To: Mercedes-Benz Dealer Principals, General Managers, Sales Managers, Service Managers, Parts Managers	From: Anthony Washington, Senior Manager, Regulations and Certifications
Re: Recall Campaign Launch Notification Model: eSprinter Model Year: 2024 Replace eSprinter Drive Motor	Date: April 2025

IMPORTANT RECALL CAMPAIGN INFORMATION

Campaign No.:	Campaign Codeword:	NHTSA ID:	Replace eSprinter Drive Motor
2025020010	V3ESCHWEI	25V090	
<p>This is to notify you of a Recall Campaign to replace drive motor on approximately 689 MY 2024 eSprinter Vans. The recall campaign will be visible on the www.NHTSA.gov website and may generate questions from customers. All affected VINs will be flagged as "OPEN" in VMI and cannot be sold until remedied.</p>			
Background			
Issue	<p>Mercedes-Benz AG, the manufacturer of Mercedes-Benz vehicles, has determined that on certain eSprinter vehicles, the welds on a helical gear within the rear axle drivetrain might not meet current production specifications. In this case, the drive load transmission within the rear axle drive train might no longer be ensured. As a result, the vehicle might lose propulsion which could increase the risk of a crash. Additio

D08.10-A040-79

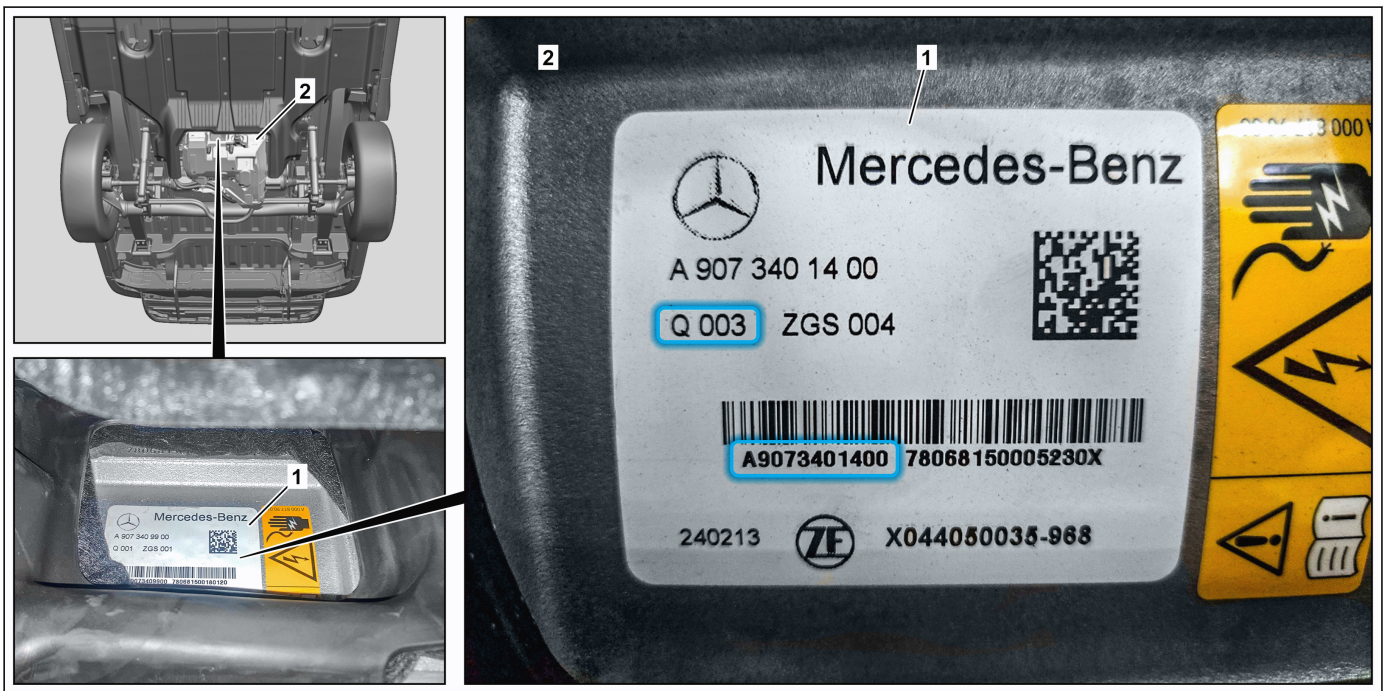
3	Check identification plate (1) at axle drive module (2).	 The A item number and the Q-status must be checked. If A item number is installed on identification plate (1) A 907 340 14 00 with a Q-status of Q005 or higher, or A 907 340 99 00, ↓ Lower vehicle and end measure. If A item number (1) A 907 340 14 00 and a Q-status less than Q005 is installed on the identification plate, ↓ Replace axle drive module (2).	
4	Replace axle drive module (2) of rear axle.  AR	 Enter new serial number of axle drive module (2) into Vehicle Documentation (VeDoc).	AR08.10-D-0007TF
5	Return or scrap old part.	 Depending on the age or mileage of the vehicle, the old part may have to be returned or scrapped.

Part no.	Designation	Quantity
A 907 340 99 00	Axle drive module	1
A 000 990 46 24	Screws (drive shaft)	2
A 907 990 15 00	Screws (axle drive module to elastomer bearing)	4
A 907 995 07 00	Line fastener	As Needed
---	Additional replacement part scopes, small parts and consumable materials required for carrying out this service measure must be replaced in accordance with the information in the repair documents referenced in this document. These are determined according to the vehicle identification number (FIN/VIN) via the "XENTRY Parts Information" system and are not listed in the parts ordering note even though they are taken into consideration in the cost framework.	As Needed
